Committee of the Whole Report For the Meeting of July 11, 2024

Subject: **Update on Rezoning Application No. 00804 for 205 Quebec Street, 507 Montreal Street, and 210-224 Kingston Street and associated Official Community Plan Amendment and Development Permit with Variances Application No. 00191**

Figure 1. Comparative Massing

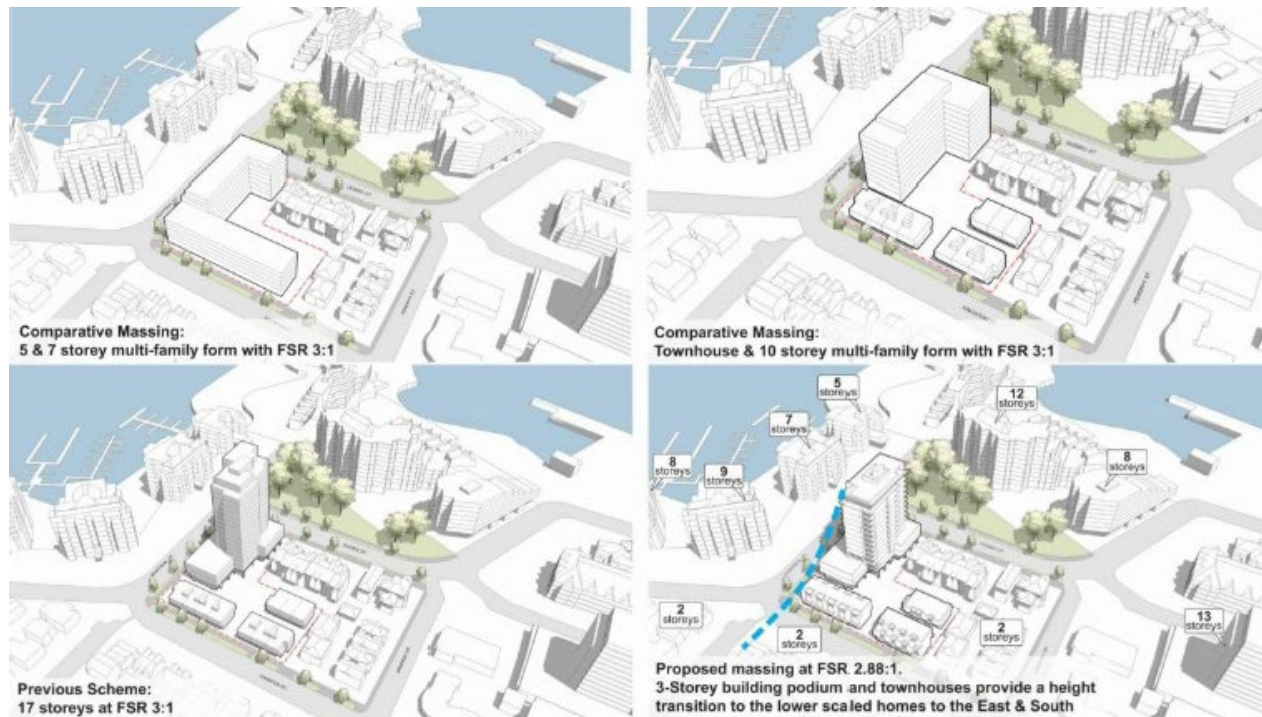
The applicant considered various building massing and siting options in response to the Council motion (see Comparative Massing below) but decided to maintain a similar proposal with a reduced height. They provided a Height and Massing Rationale which is included with their letter to Mayor and Council attached to this report. Staff believe that it would likely be easier for the applicant to design a proposal to be more consistent with City policies by exploring different massing, such as an approximately six-storey building towards the north end of the site and lower scale buildings towards the south, however, it would likely be challenging to retain the density of the previous proposal with this approach, which is one of the goals of the previous Council motion.
